## DEVIATION REQUEST AND DECISION FORM

Project Name : Retreat at Prairie Ridge Filing No. 2  
Schedule No.(s) :  
Legal Description :

A deviation in accordance with the Paving Season 2024 – UPDATED is requested.

**SITE AND EXPLORATION PLAN**  
 RETREAT AT PRAIRIE RIDGE F2 DINES BLVD N  
 CLASSIC COMMUNITIES

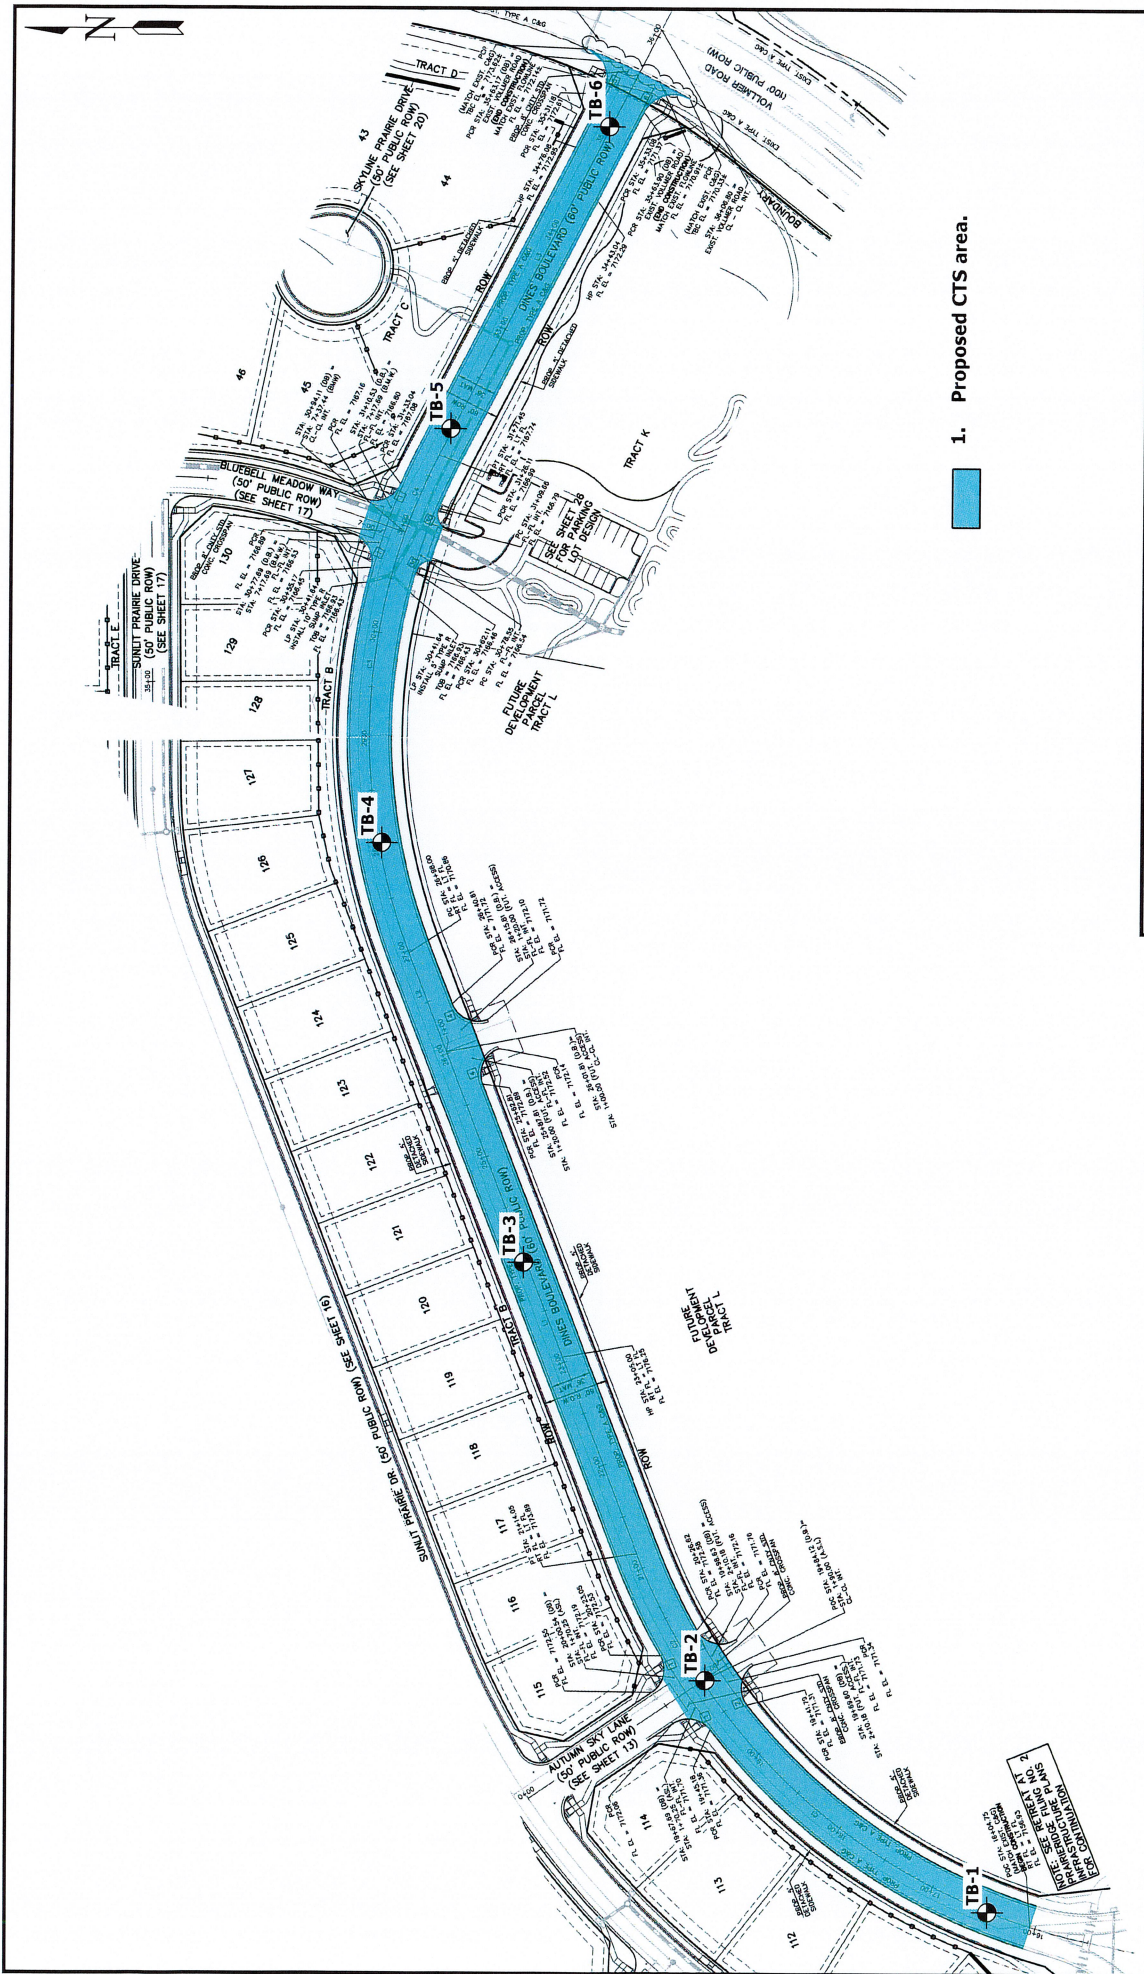
A deviation in ECM D.4.1.F is requested to use a composite section of asphalt and cement treated subgrade (CTS) as opposed to a composite section of asphalt over aggregate base course.

The development filing is Retreat at Prairie Ridge, Filing No. 2. The roadway included is a portion Dines Boulevard. The limits are shown in the attached figure.

An exhibit displaying the areas to include CTS is attached with this deviation request.

This request has been determined to have met the criteria for approval. A deviation from Section D.4.1.F of the ECM is hereby granted based on the justification provided.
